UNITED STATES PATENT AND TRADEMARK OFFICE

10/531,398

Office Action Summary	Application No. 10/531,398	Applicant(s) HUI TSING, ALBERT JAN	
	Examiner Jason Crawford	Art Unit 2819

DETAILED ACTION

Reference Fig A (Claims 2-7)

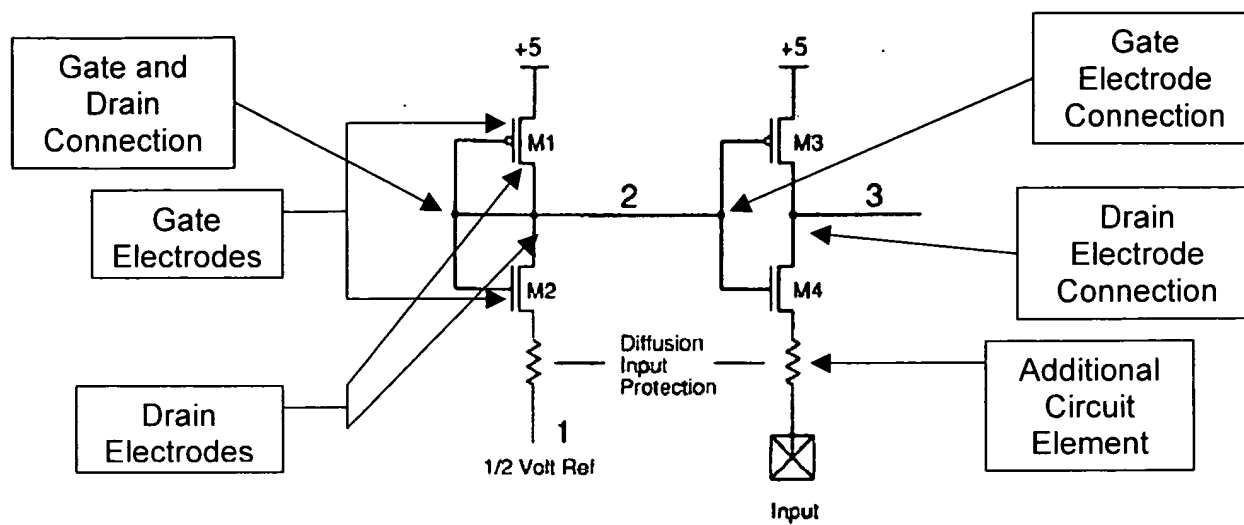
In regards to Claim 2, Knight discloses of a fail-safe circuit in Fig 11 for producing a fail-safe output signal (3) in case of an open circuit condition (i.e. if the input voltage is lower than the constant voltage of 2) of an input pad (Input) of a digital circuit unit comprising a first inverter stage (M1, M2) providing a constant switch level (at 2), a second inverter stage (M3, M4) providing a variable switch level that depends on the signal level of the input pad (Input) and comparing (at the source of M4 and gates of M3 and M4) the constant switch level (2) of the first inverter stage (M1, M2) with the variable switch level of the second stage (M3, M4) and providing an output signal at an output terminal (3) if the variable switch level of the second stage (M3, M4) is greater than the constant switch level (Fig 12 (c)) and an additional circuit element (Diffusion Input Protection resistor shown between M4 and Input), See **Reference Fig A** below) connected in series with the second inverter (M3, M4) for decreasing the switch level of the second inverter stage (M3, M4, the resistor will have a voltage drop across it, thereby decreasing the switch level). (Fig 11, Pages 461-463)

In regards to Claim 3, Knight discloses of the first inverter stage (M1, M2) is a transistor stage (comprised of transistors M1, M2) and wherein the gate electrodes and the drain electrodes of the transistors (M1, M2) of the first inverter stage are connected to each other (See **Reference Fig A**). (Fig 11, Pages 461-463)

In regards to Claim 4, Knight discloses of the second inverter stage (M3, M4) is a transistor stage (comprised of transistors M3, M4) and wherein the gate electrodes of the transistors of the second inverter stage (M3, M4) are connected to each other (See **Reference Fig A**) and wherein the drain electrodes are connected to each other (**Reference Fig A**). (Fig 11, Pages 461-463)

In regards to Claim 5, Knight discloses of the gate electrodes of the second inverter stage (M3, M4) are connected (at 2) to the gate electrodes of the first inverter stage (M1, M2). (**Reference Fig A**, Fig 11, Pages 461-463)

In regards to Claim 6, Knight discloses of the input terminal (Input) is connected to a source electrode (source of M4) of the second inverter stage (M3, M4). (Reference Fig A, Fig 11, Pages 461-463)

In regards to Claim 7, Knight discloses of the output terminal (3) is connected to a drain electrode (drain of M3 and M4) of the second inverter stage (M3, M4). (Reference Fig A, Fig 11, Pages 461-463)

Reference Fig B (Claim 11)

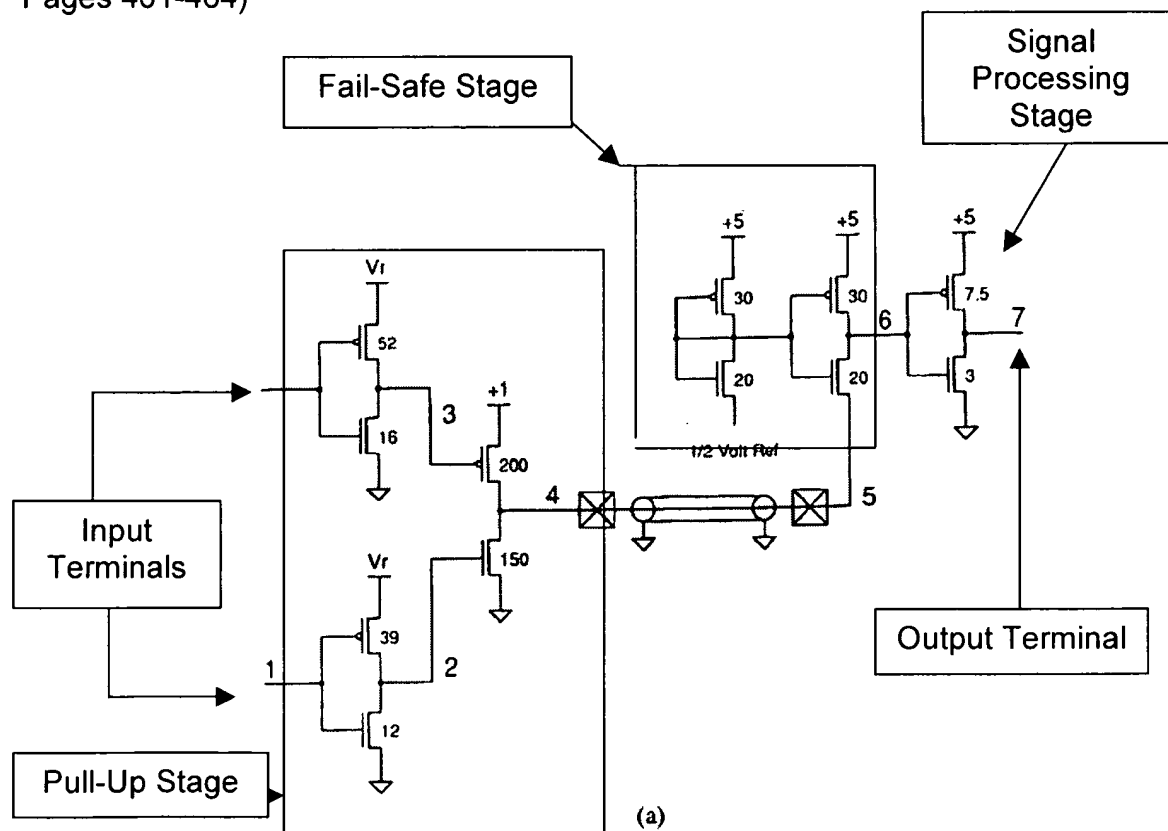
In regards to Claim 11, Knight discloses of the digital circuit of Fig 12(a) unit further comprising an input terminal, a pull-up stage, the fail-safe circuit, a signal processing stage and an output terminal (7). (See Reference Fig B below, Fig 12 (a), Pages 461-464)
